CHURCH AVENUE CLIFF ISLAND  
109B-F-38

Subject: Building permit for alterations  
in the cottage of Dr. F. H. L. Taylor  
(Assessor's Lot No. 109b-F-38) Island  
Avenue, Cliff Island, Maine. Church, Are

Subject: Application for building permit to cover alterations in ext. of Dr. F.H.L. Taylor (Assessor's Act No. 109b-F-38) Island Ave., Cliff Island, Maine.

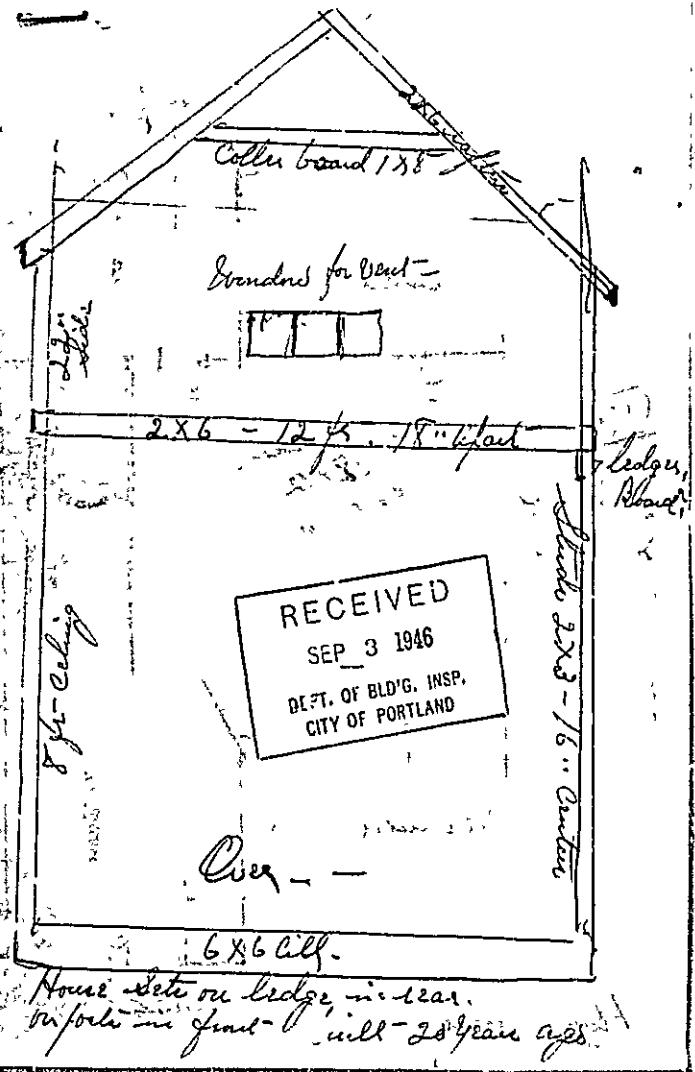
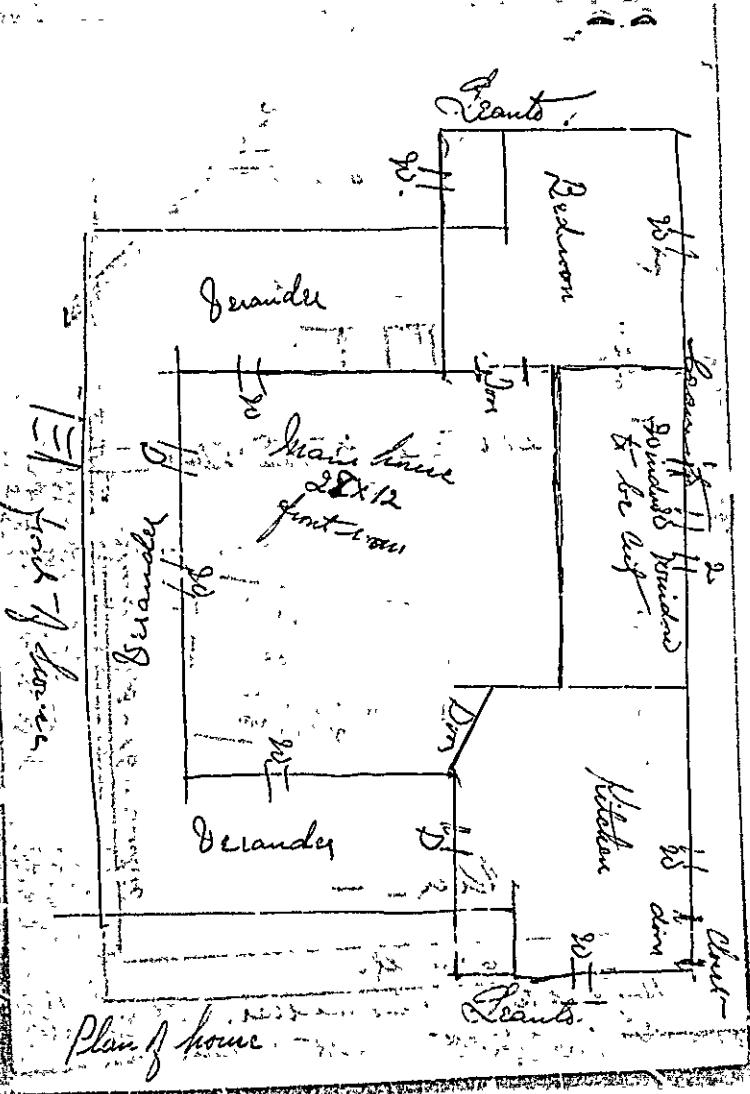
According to the rules of strength contained in the Building Code the 2x6 joists on 14-foot spans and 18 inches from center to center would figure out about one-third short of the strength usually required on the second floor of a dwelling house even if there were no ceiling in first story and not making any allowance for the weight of the new partitions which you are to erect on the second floor. Though light wallboard (not plasterboard) is used the weight still adds up to about five pounds or so to the square foot if you are to use the required minimum of 2x3 studs set upright no more than 16 inches from center to center.

Since, as I understand Mr. Nickerson's sketch, there is only 22 inches at the outside walls from surface of second floor to the lower ends of the rafters, and since there is to be no stairway but only a ladder to reach the second floor, we shall not greatly object to using 2x6's as shown. Certainly, however, they should be doubled beneath any partitions which are parallel to them.

No mention is made of the size of the present beams, but presumably they are merely ceiling joists and not intended for floor loads. Perhaps the spacing of 18 inches ~~is~~ <sup>is</sup> intended to be used because of the spacing of present joists. If not, it would be best to space the joists no more than 16 inches from center to center and double them under partitions. As a matter of fact, I think the owner might be better satisfied to make these joists 2x8 anyway, and then if he wants to put in a regular stairway and finish off more rooms up there, there will not be any question about it.

Apparently three rooms are to be finished off in first story, and the wallboard on these partitions and on the inside of outside wall and on the ceilings will all add weight to the building. I presume Mr. Nickerson will see to it that the first floor construction is strengthened if necessary to support this additional weight.

The int'ations are that the new 1x6 floor joists, 16 inches from center to center, on spans of 12 feet proposed under second floor would not be strong enough. Before that can be told, we must have a framing plan and cross-section showing how much of the 12-foot spans could be occupied (perhaps limited by the slope of the roof) and the location of the partitions.

Now as I see it - there new 2x6 floor  
beams would strength up the cottage  
so I would look them over the ledges  
board. Also bridge them in.  
then I am only to use wall board for  
walls & ceilings so to keep it light  
and no Sheetrock. I usually feel it would  
help. Not weaken it.

It has a brace on 2 sides and 1 end  
and a verander across front - is well  
braced. I have draw a sketch of  
part of main building or up stairs from  
there will be no stairs. only a ladder  
on wall really like an open air
